**Docket:** NRC-2012-0192

Southern California Edison, San Onofre Nuclear Generating Station, Units 2 and 3; Application and Amendment to Facility Operating License Involving Proposed No Significant Hazards Consideration Determination

**Document:** NRC-2012-0192-DRAFT-0001  
Comment on FR Doc # 2012-20114

## San Onofre Nuclear Generating Station Exclusion Zone

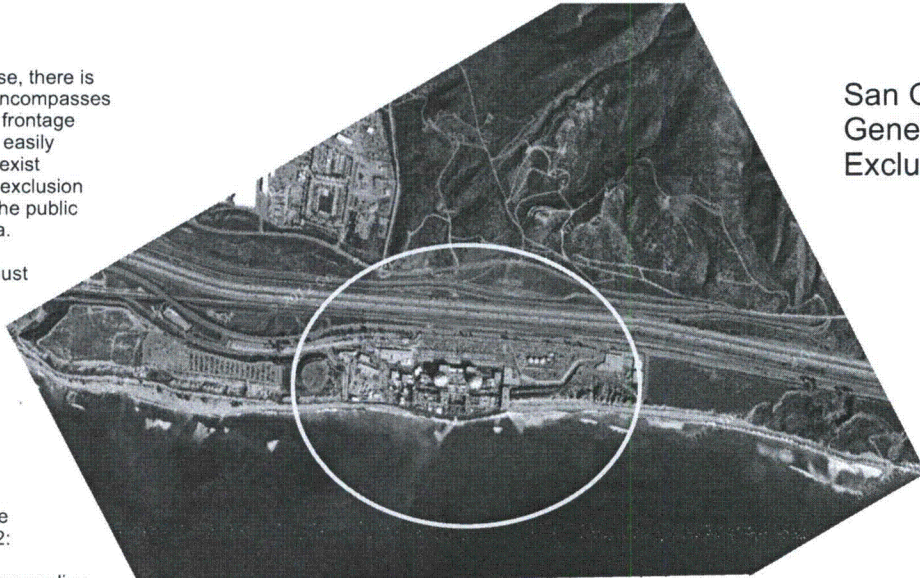
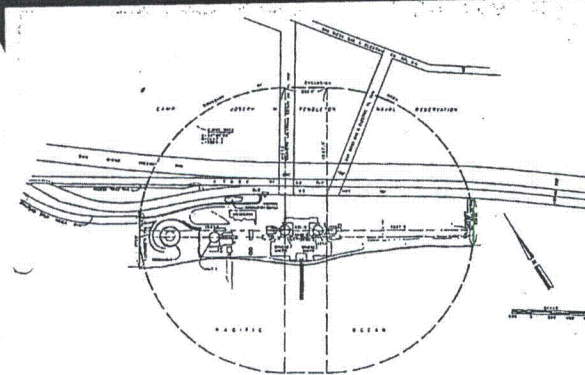
=====  
--> The exclusion zone at San Onofre Nuclear Generating Station includes a freeway and an accessible beach. There are no signs warning people that ingress to the area may subject them to

---> Contrary to the definition of an exclusion zone, there is no means to stop traffic on the freeway in the event of a SGTR or LOCA, events that can progress within minutes and may require the complete shutdown of the freeway. Licensee should be required to install gates and turn-arounds to allow that traffic be completely stopped on the freeway and rerouted to other roads.

According to the San Onofre license, there is an exclusion area defined which encompasses a large section of the freeway, the frontage road, and the beach area which is easily accessible to the public. No signs exist informing the public that this is an exclusion area and concern for radiation to the public occurs at the boundary of this area.

The license also says that there must be a way to control traffic on the roads next to the plant but there is no control to this area of the freeway that I have seen. I would think they would have to install lights and gates at the previous overpass so cars can be easily stopped and turned away.
